| Title: Susitna-Watana Hydroelectric Project, FERC Project No. 14241-000 ; Review of Initial Study Reports | | SuWa 292 |

Subject: Susitna-Watana Hydropower Project, FERC Project No. 14241-000; Review of Initial Study Reports

Enclosure 3: Individual study requests for modification and new study

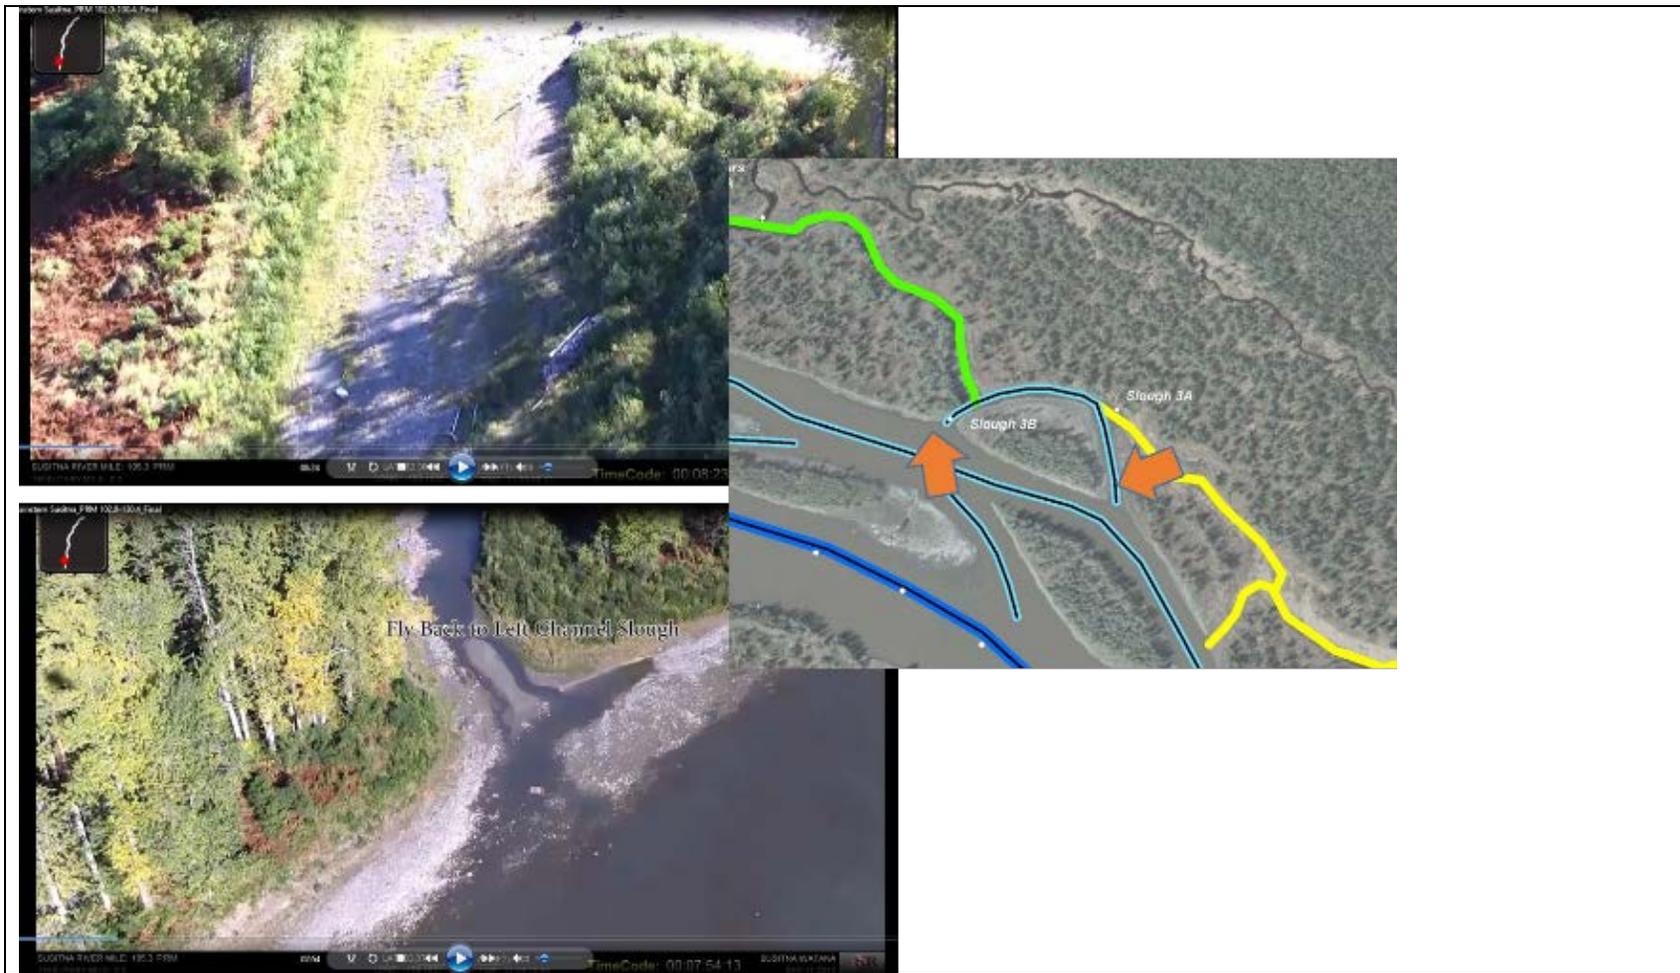
The connectivity and clarity of Slough 3b and Oxbow I from aerial videography were shown in Figure C7 and C8. In this videography, the upstream ends of both sloughs are not overtopped and the water appears clear. Since the channels at PRM 119 (SCR Appendix A Map 45, 2015) are not overtopped and the water appears clear on videography (Figure C9), these sites also should be classified as side sloughs; however, they are classified by AEA as side channels. The channel in FA 128 (Slough 8A) is classified as a side channel; however, the upstream end is not overtopped on the videography and the water appears clear (Figure C10). It is unclear why channels in FA 104 and FA 113 are classified as side sloughs and the channel in FA 128 is classified as a side channel when they appear exactly the same on the 2012 aerial videography.
